URBAN DESIGN STANDARDS

10 | Street Sections

PUBLIC IMPROVEMENTS PLAN

FENCING

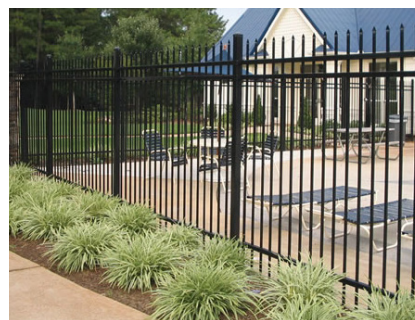
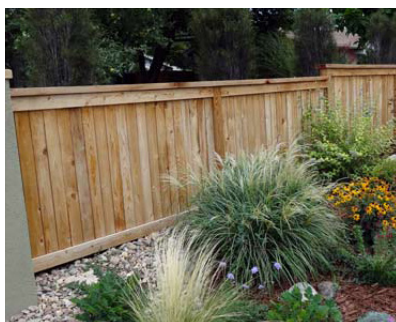
The examples provided below do not seem to represent any design theme. They are just a selection of fence types. If needed, Planning staff can again provide the consultant with specific examples of how this was addressed in other Master Plans.

Response: Fencing has been updated to reflect actual fencing proposed with the Preliminary Plat/Site Plan application.

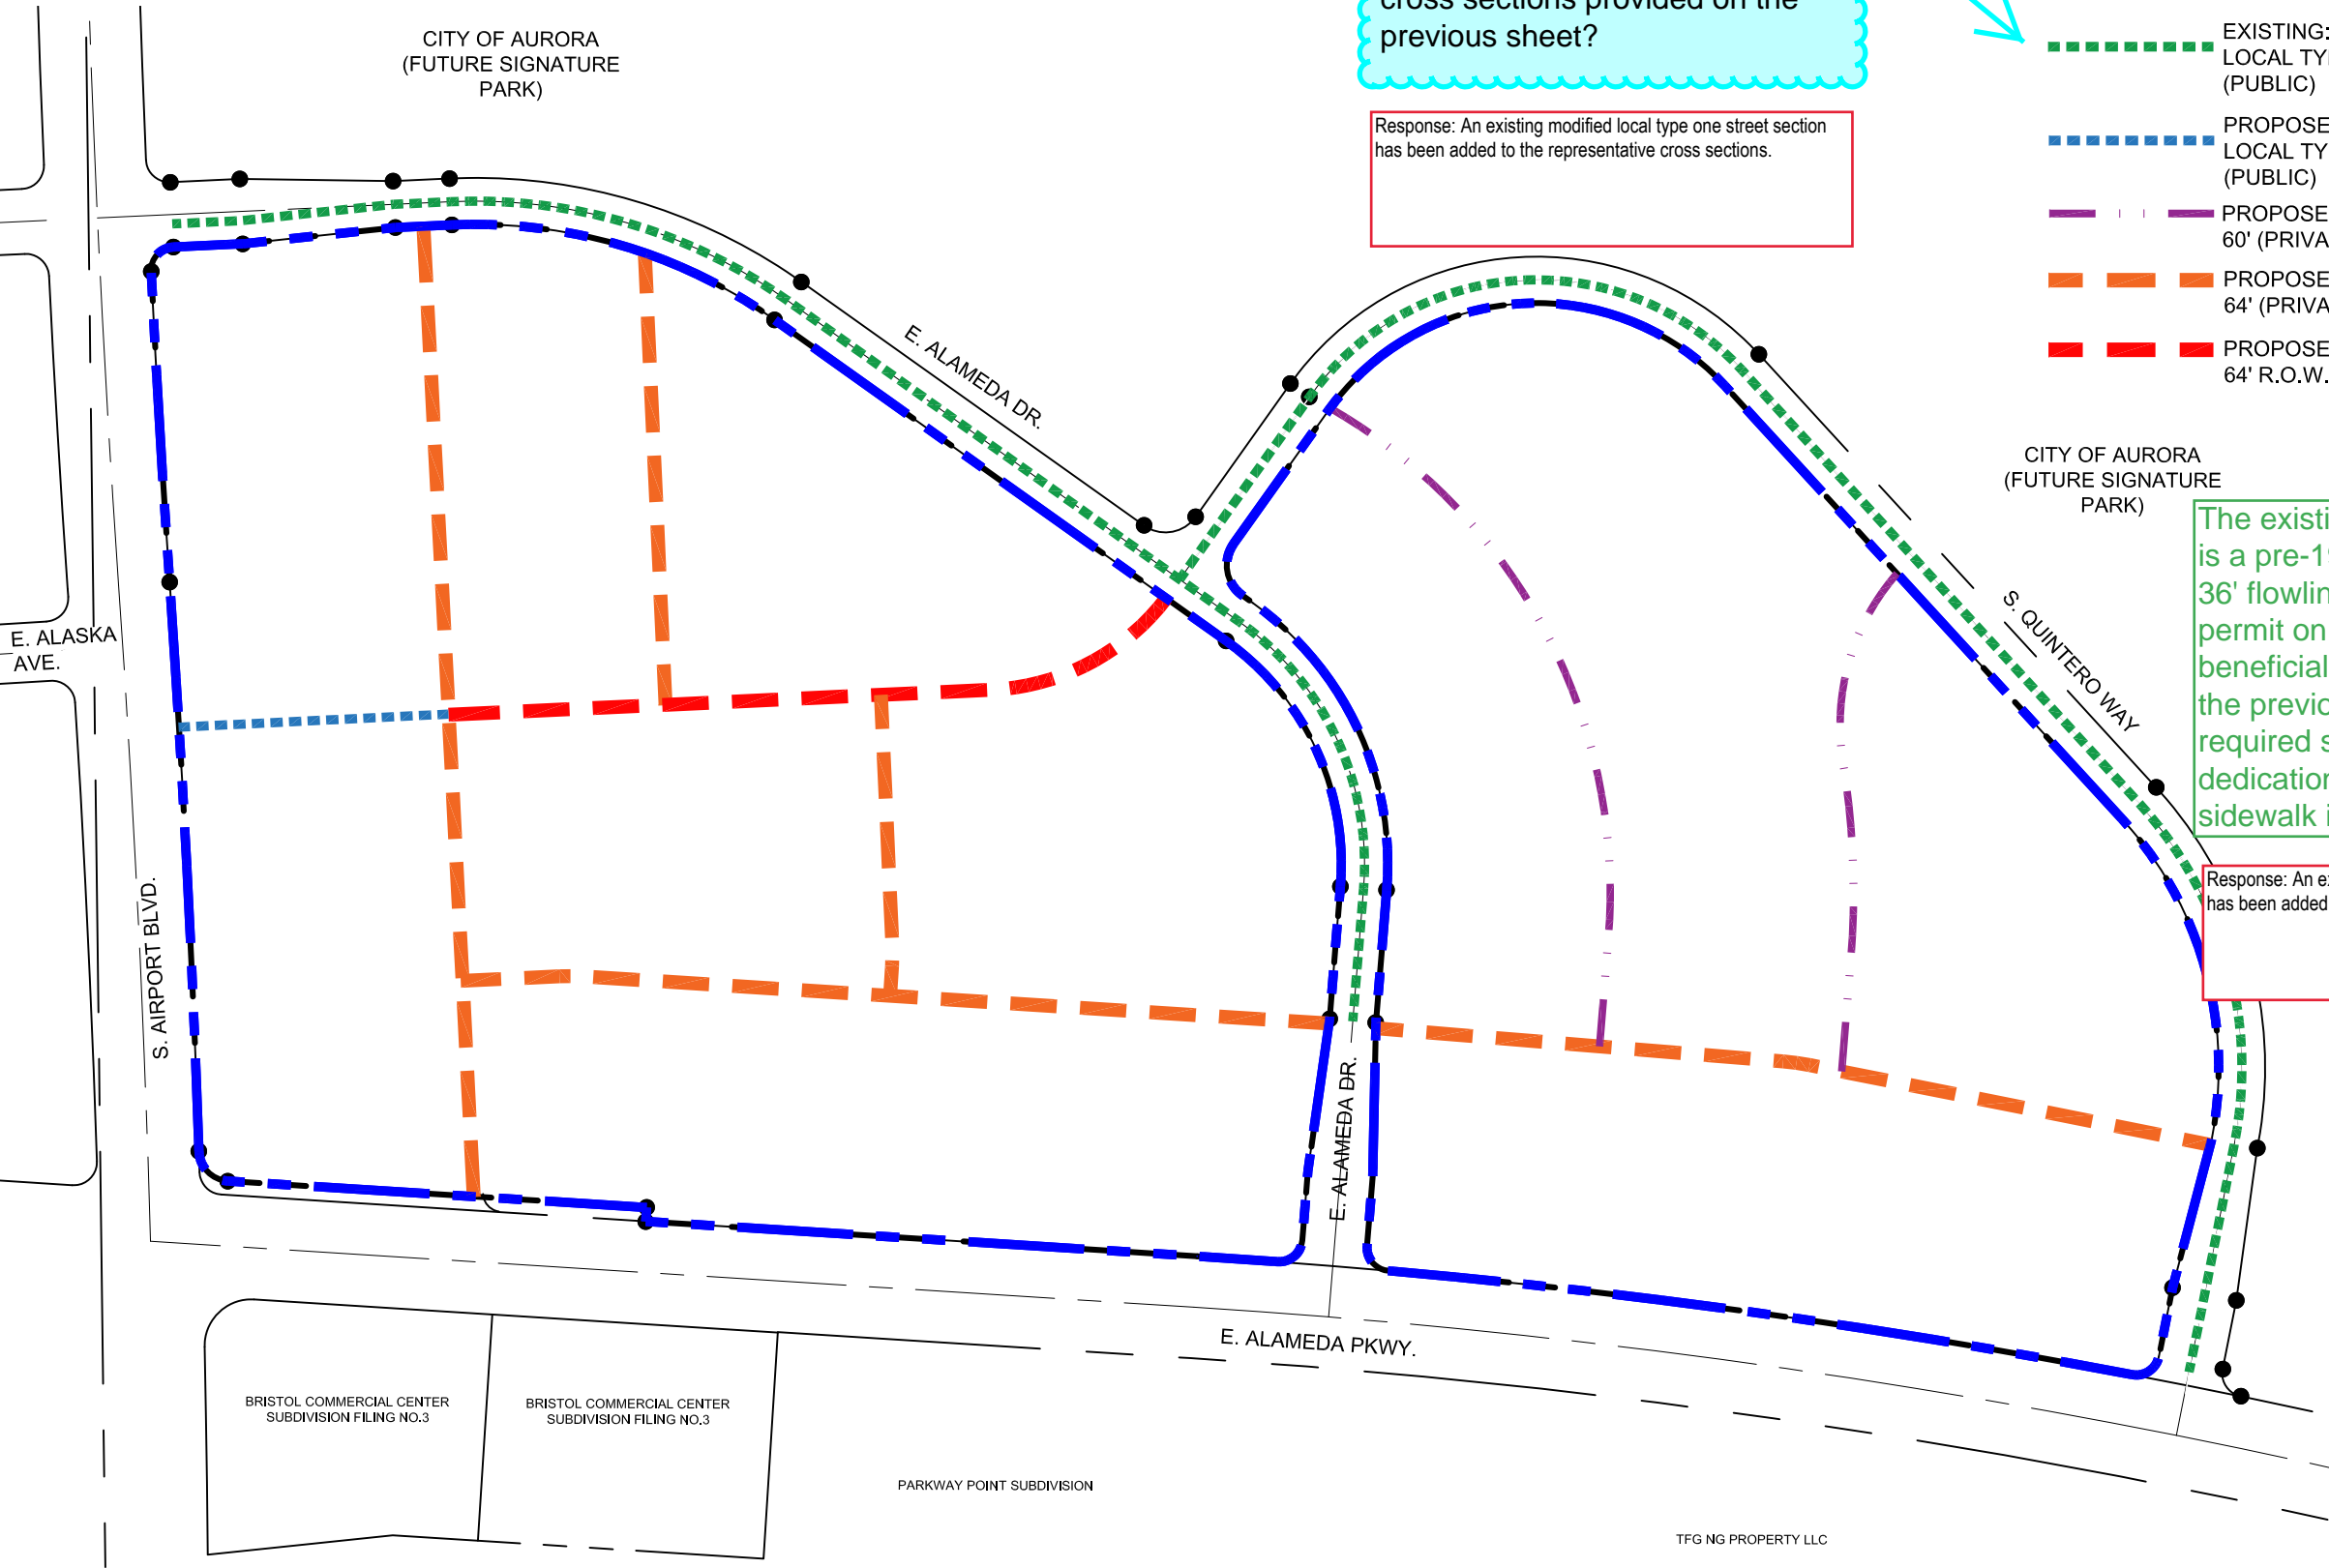
Is this existing modified local type 1 street represented by any of the cross sections provided on the previous sheet?

Response: An existing modified local type one street section has been added to the representative cross sections.

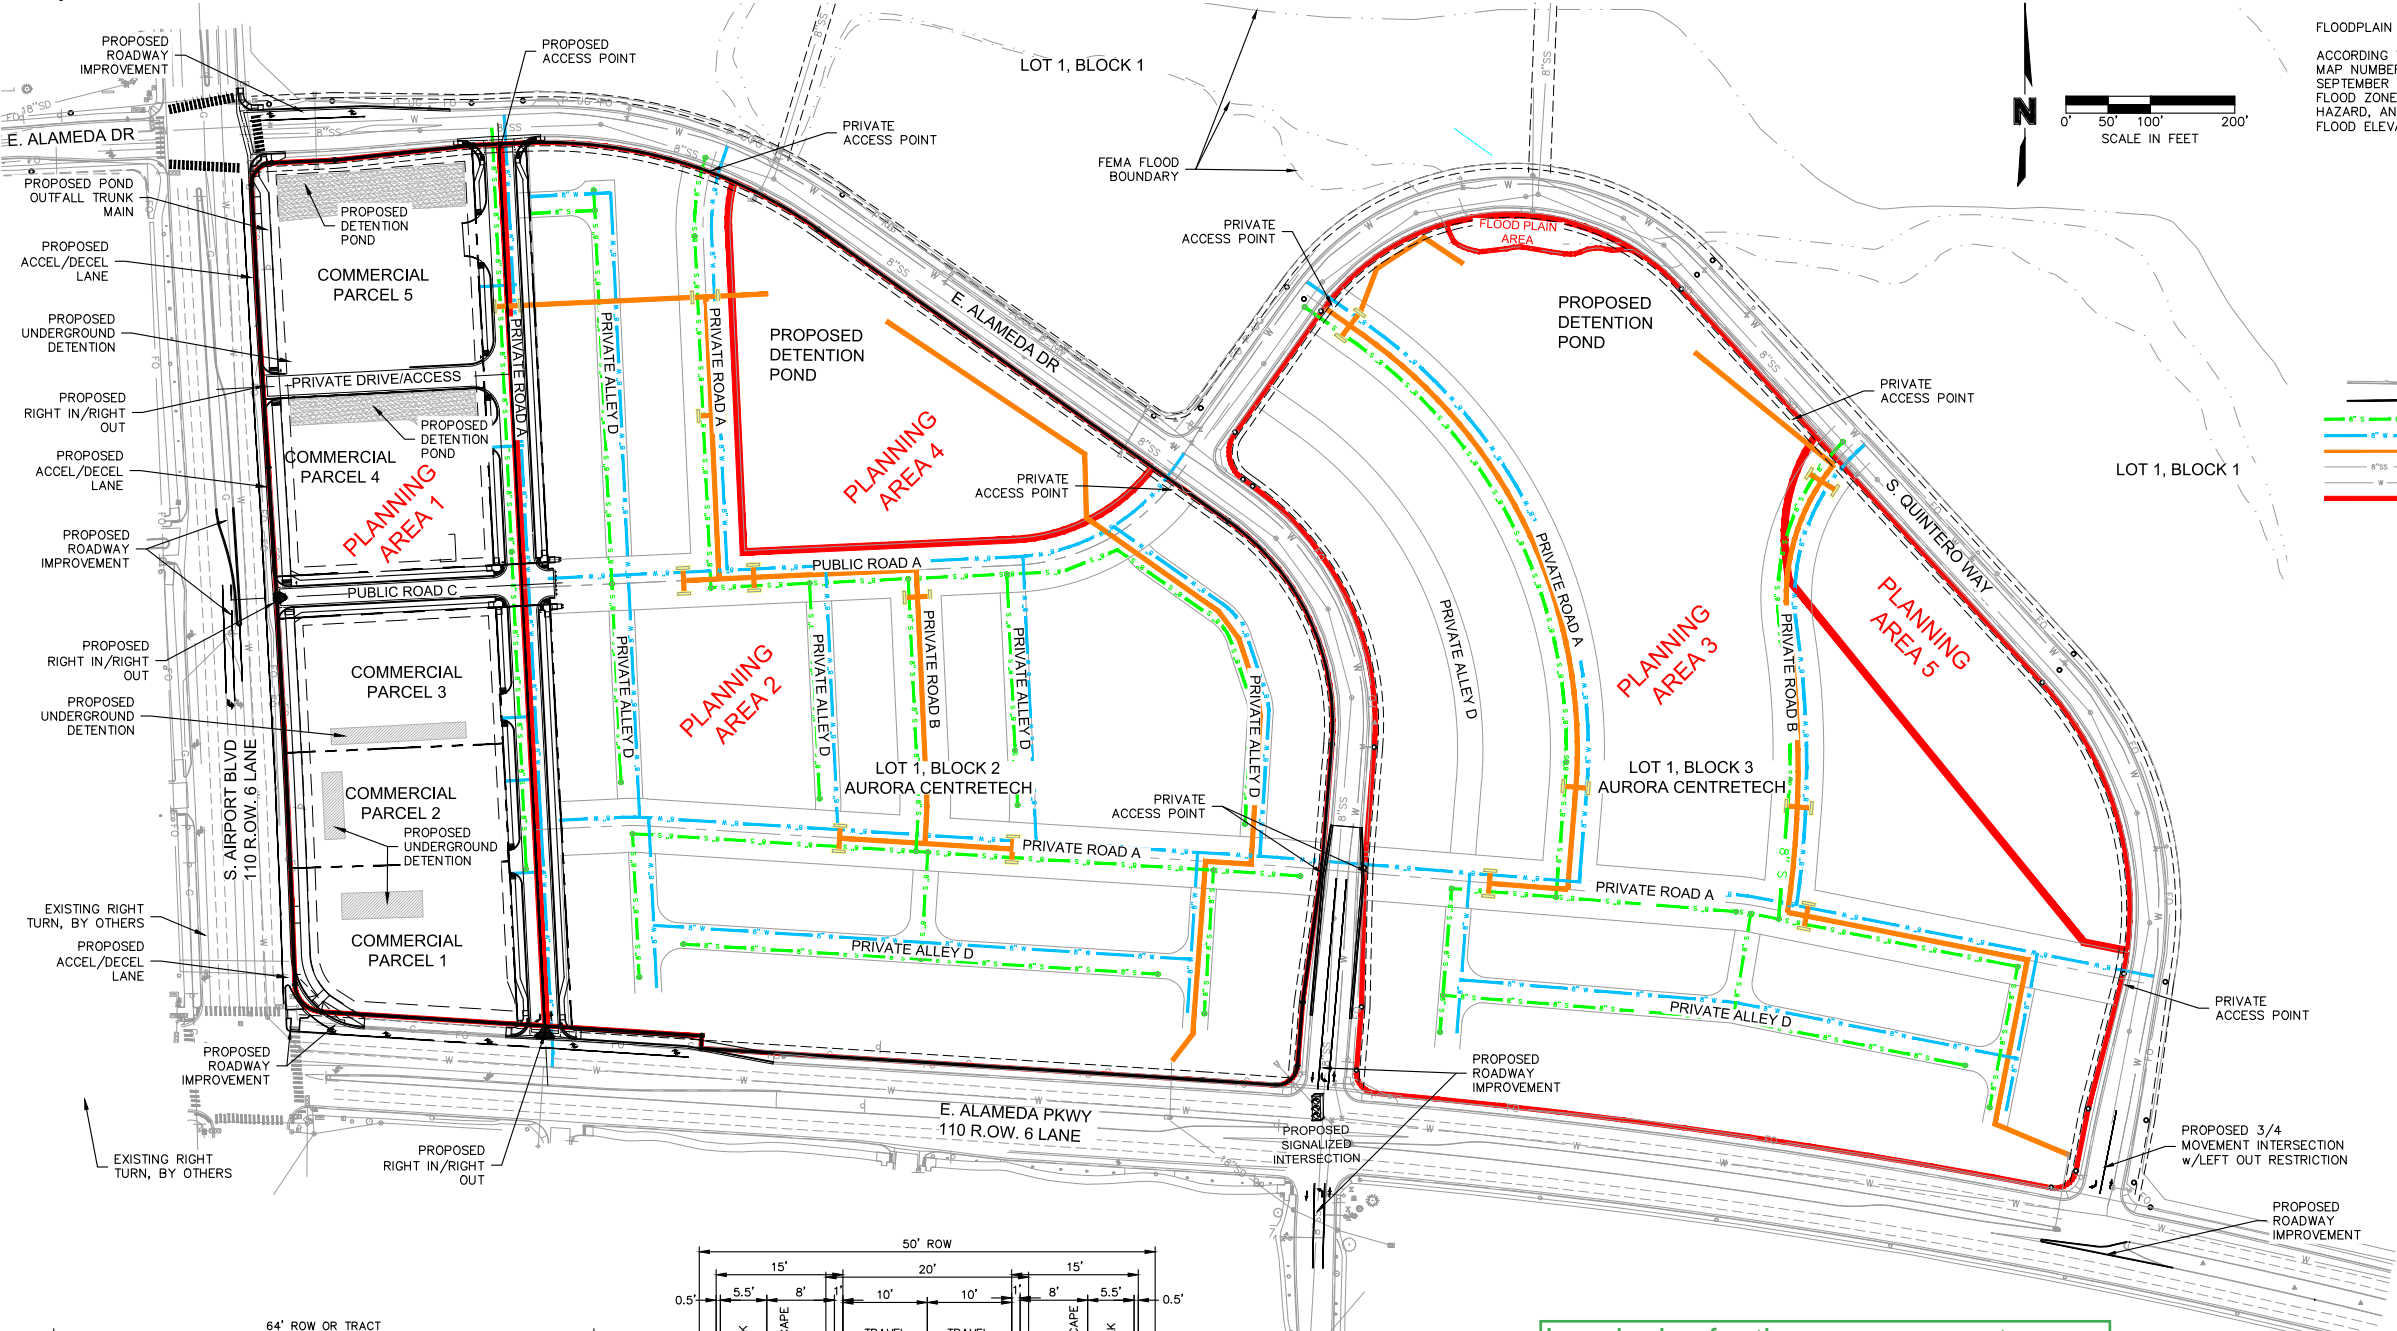
The existing Local Type 1 (50' ROW) is a pre-1999 section and includes 36' flowline to flowline which would permit on street parking. It may be beneficial to include this section on the previous sheet and show the required sidewalk easement dedication once the detached sidewalk is constructed

Response: An existing modified local type one street section has been added to the representative cross sections.

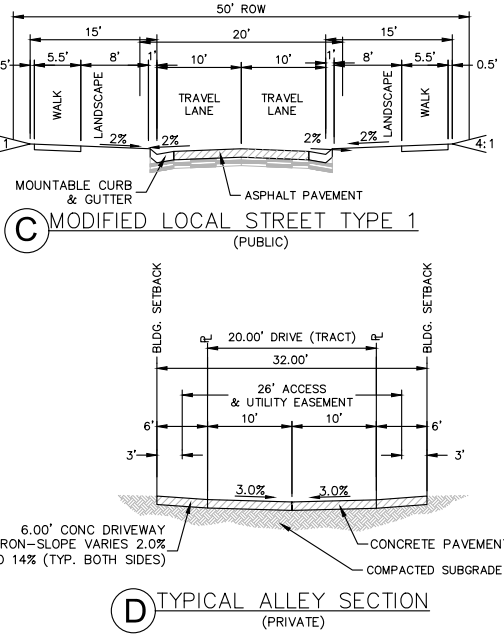
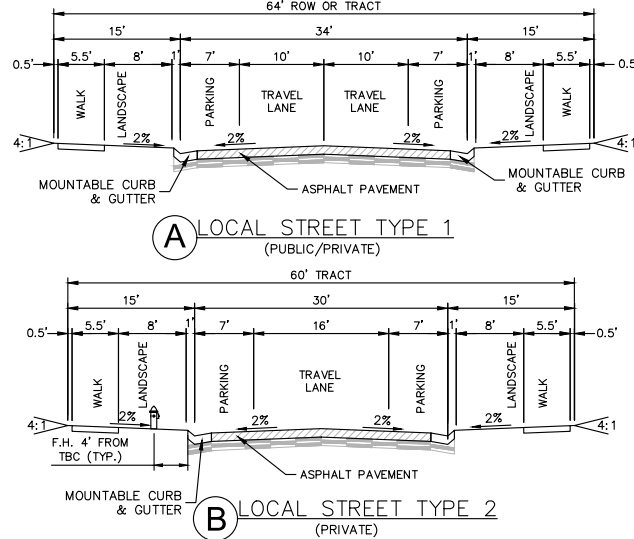
I apologize for the new comment. Please provide a section for Airport, Alameda Pkwy, Alameda Drive and Quintero Way that indicate the required improvements along those streets. If a section is not provided, please include the required improvements in the narrative.

OLSSON RESPONSE 4/2/2021
DESCRIPTIONS OF EACH "OFFSITE" IMPROVEMENT ARE ALREADY CONTAINED WITHIN THE PIP NARRATIVE. TO AID IN THE CITY'S REVIEW, WE'VE ADDED STREET SECTIONS TO THE PIP FOR EACH "OFFSITE" IMPROVEMENT, AS WELL.
